Office Action Summary	Application No. 10/511,070	Applicant(s) JONES, STEVEN VICTOR	
	Examiner Katherine W. Mitchell	Art Unit 3677

DETAILED ACTION

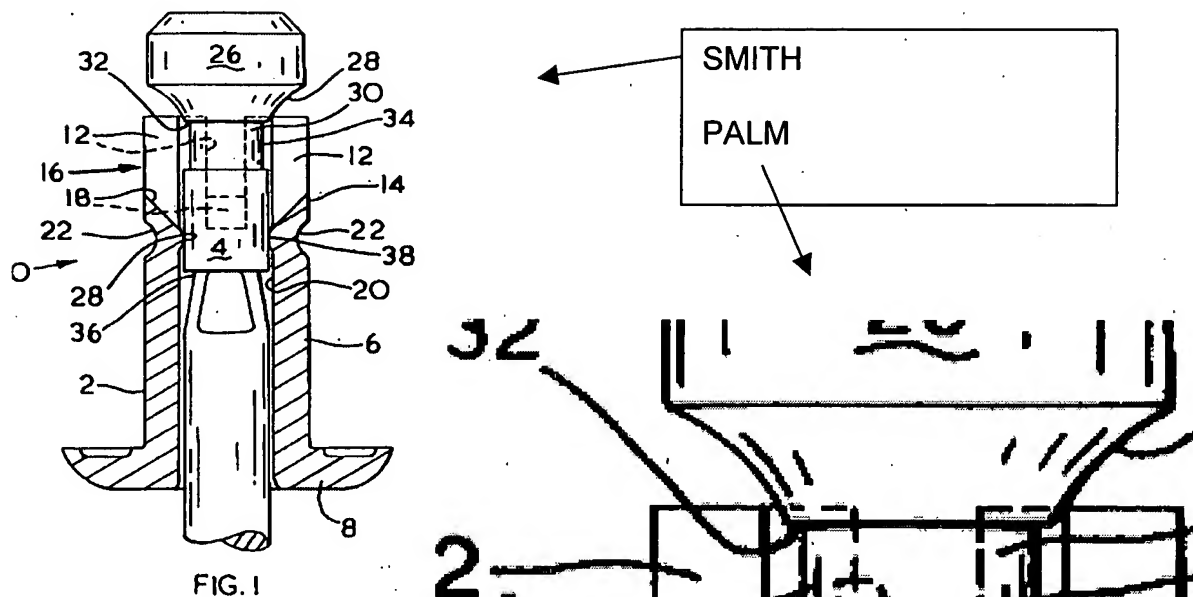
Re claims 3 and 6, 14 and 17: Looking at the slope of the bottom edge of the groove, identified as 18 in Fig 1, it is clear the slot increases in length as it extends from an outer surface to an inner surface. (see also page 3 lines 7-10 and page 6 lines 1-4)

Re claim 5, 16: Page 3 lines 21-23 teach equal

Note perpendicular
shoulder at 32

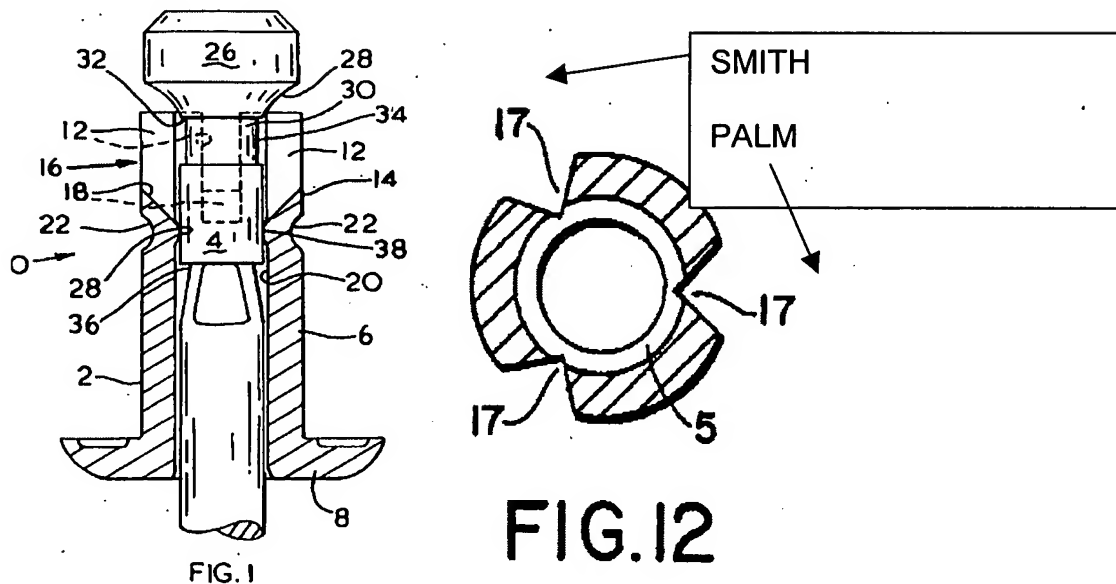
Re claim 7-8, 18: Fig 1 shows constant thickness

that the external diameter of the body is constant along

Re claim 10: Fig 1 above shows the maximum diameter of the head equal to the OD of the shank.
